Evidence from a NYS licensed inspectors
that striker plates are needed for
CSST gas line (flex pipe) installations

This page is an addition to the code violation report that was delivered to the Town Supervisor in June of 2020. Below is an email response verifying the standard requirement of striker plates to be used with CSST gas lines.

RE: Code violations/complaint

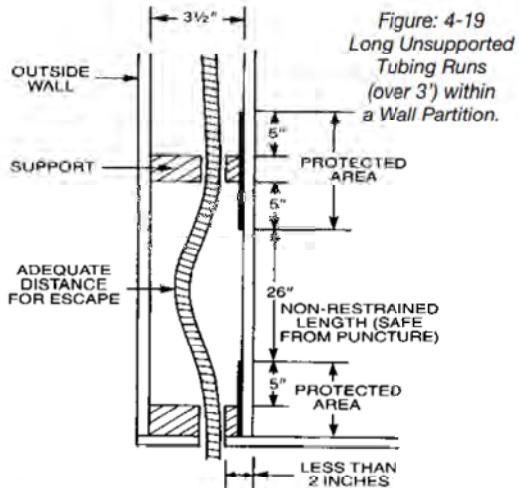
IFGC Section 407.2 Still no straps, brackets or hangers etc to hold pipes in place which would cause friction against objects beneath the floor board. This falls in line with the Marshal's theory of how the leak happened.

Pipes not secure to anything. They just come from beneath the floor at an angle into the furnace, which could also damage the unit internally due to physical contact.

IFGC Section 409.3.1, 409.1.2 and 409.1.3, Are still in violation, as the shutoff valve for the furnace is in a concealed and prohibited location behind a locked door. There is no tenant access to the shutoff valve for the furnace and main (overall) gas supply. **IFGC Section 411.1.3.4,** there is no shutoff valve ahead of

the connector flowing upstream (IFGC Section 409.5.1). The valves where it belongs which is prohibited (see orange circle in picture above).

Figure: 4-16 Multiple outlets along main tubing run

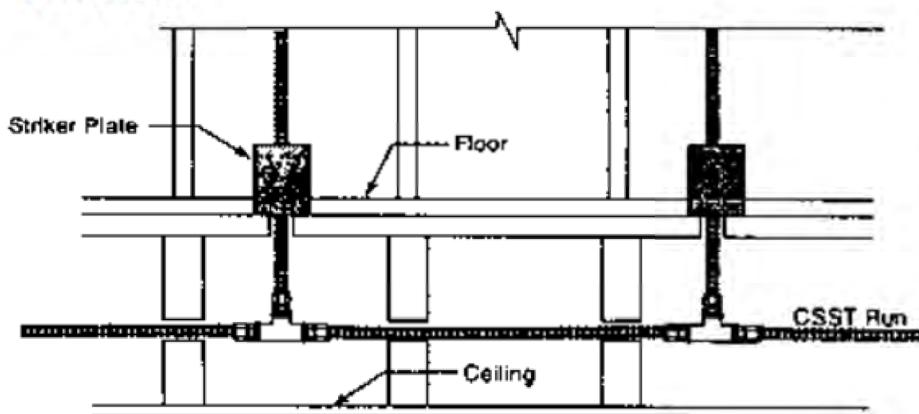
This is an illustration of what is supposed to be installed in my apartment building, every unit. The RG&E Tech said that he thought it was not installed properly because it was "missing a metal base to hold it sturdy". He said out of all of the inspections he did, this one stood out, as it is missing something like a metal base to hold the CSST firm so that it would not move.

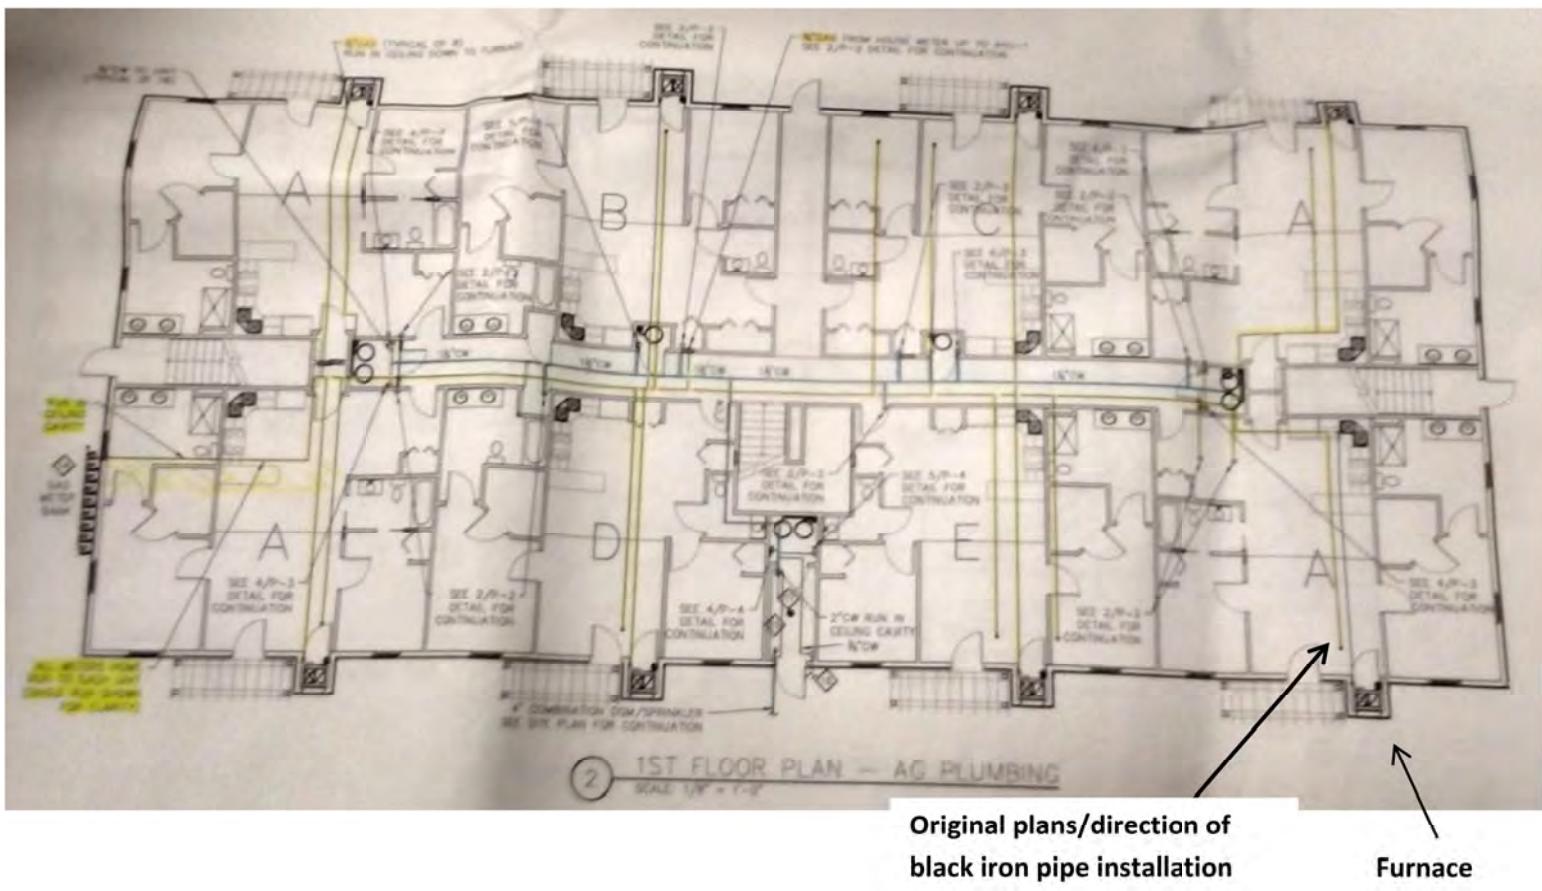
Below is the layout of what the Fire Marshal explained as the original approved plan that was improperly deviated from. This was explained to me the day I made the impromptu visit on 1/7/20. The drawing illustrates pipes that are in the opposite direction of how the current pipe is installed. The current pipe appears to go in the direction of the bedroom next door to the furnace closet. The arrow in the picture on last page looks to be in the direction of what the pipes should be routed based on the original approved plans.

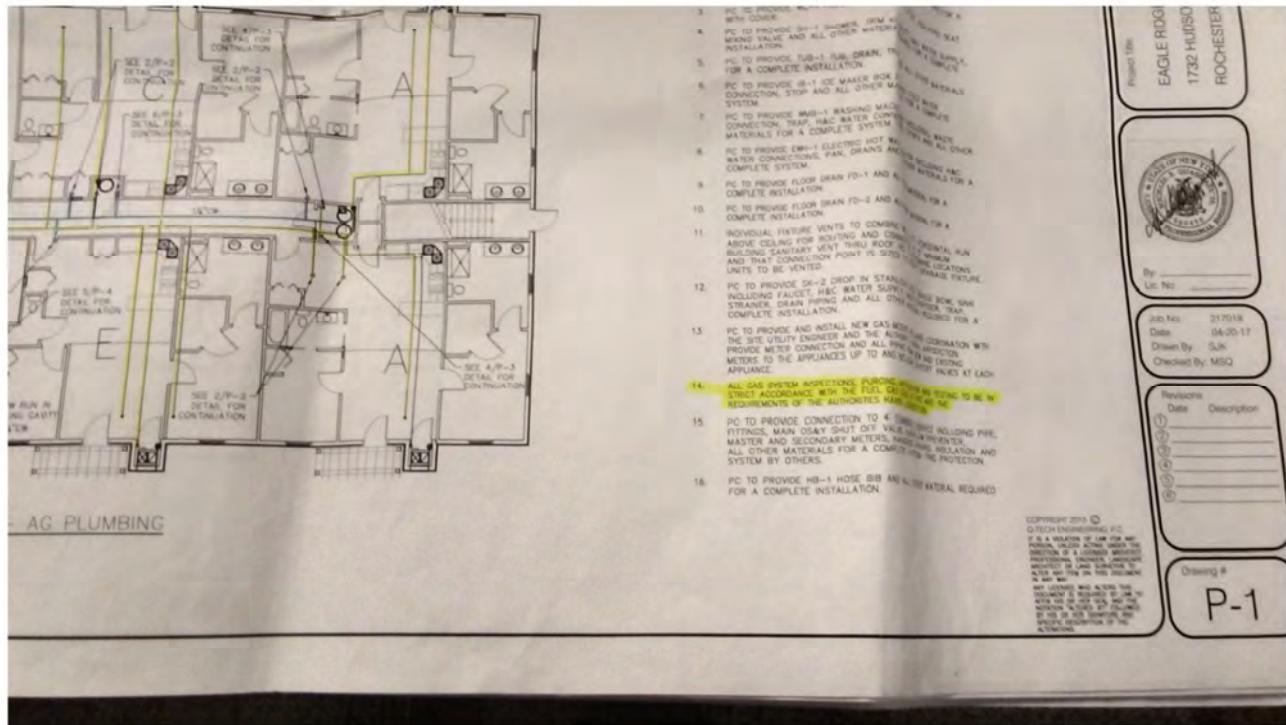
Notice the yellow highlighted lines on this layout. This is where the lines were highlighted to indicate the original approved directions of the pipes. The Marshal explained this drawing of how the pipes are supposed to be and its now "as built" nature, when I made the visit. I took this picture after he explained the pipes.

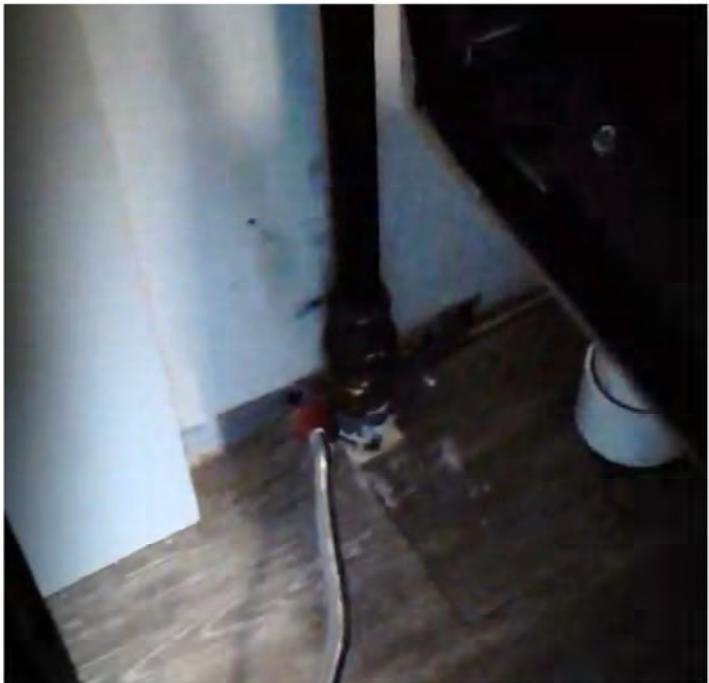
Seeing that the Landlord would not do anything about my notices and complaints, I purchased a gas detector/meter to prove my suspicion. On 10/24/19, I sent an email complaining of the smell of gas with videos showing the actual leak out of the pipe. I already had issues with the maintenance crew entering my apartment without my consent, and someone had been there without my presence and left the furnace closet door open. I was able to pinpoint the gas leak with my detector/meter and send the Landlord video proof. That is when the Landlord began to send uncertified repairman over to attempt to fix the leak without the presence of RG&E and the Fire Department yet in my presence. Video proof can be provided. Here are some of the pictures of the gas leak detected by my detector/meter:

Video proof of the leak detected outside of the furnace closet and from the HVAC vents. Gas was actually coming out of the vents in small trace amounts.

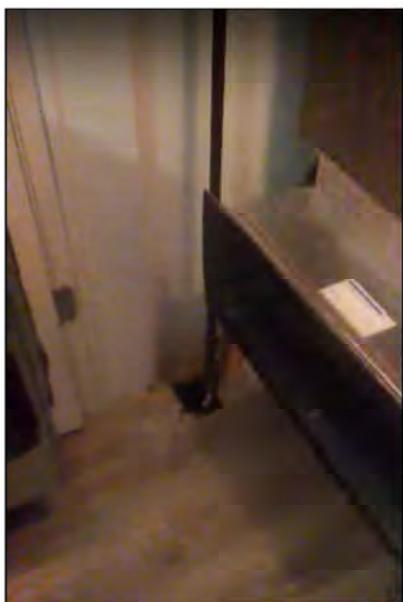
This picture directly to the left is from one of the first videos sent to the Landlord on 10/24/19. Please bear in mind that it took the Landlord about a month to fix this leak once I sent tangible evidence of this leak. It appears to be evident that prior to this video, the Landlord had been working on this leak, as there is caulking (code violation) all around the base of this connection.

It was so much gas that the detector/meter could pick it up outside of the furnace with the furnace door closed. When the maintenance crew would come over and open the door, I would tell them that I smell gas but they would say that it wasn't a leak and that it is normal for a unit to smell the way it did when the door was opened.
